PREVOST

WARRANTY BULLETIN

WB23-39

DATE:	November 2023	SECTION:	18 BODY
EXPIRATION:	November 2025		
SUBJECT:	MODIFICATION OF THE WIPER MECHANISM ACCESS HATCH SEAL

3. Localization of the seal.

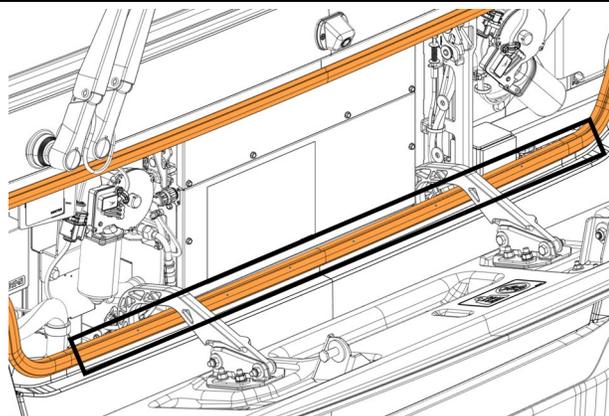
On the vehicles affected by this bulletin, wiper mechanism access hatch seal needs to be modified to avoid water seepage into the compartment.

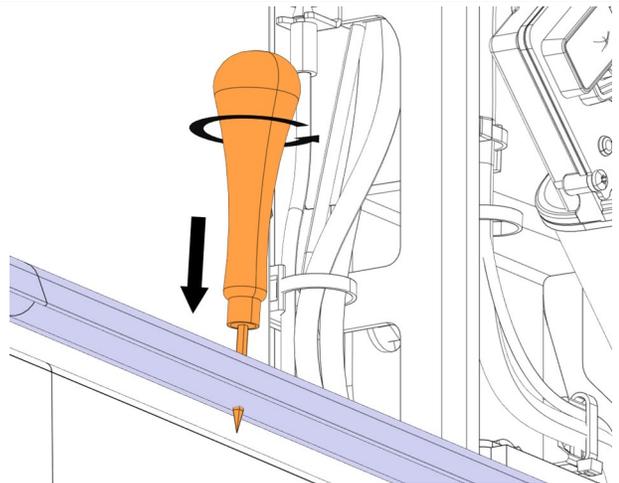
6. Use the existing holes at the bottom and punch the joint from edge to edge and let a hole melt by making small circles to ensure the new hole does not close-up.

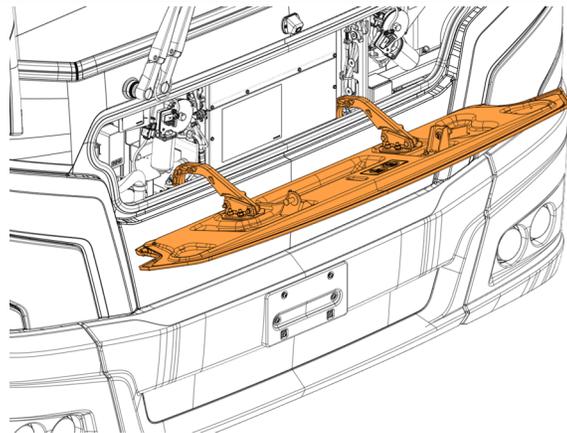
Be careful not to touch the paint with the hot punch. Put protection (plastic, wood, leather) under the seal when you drill with the hot punch that will avoid paint damage.
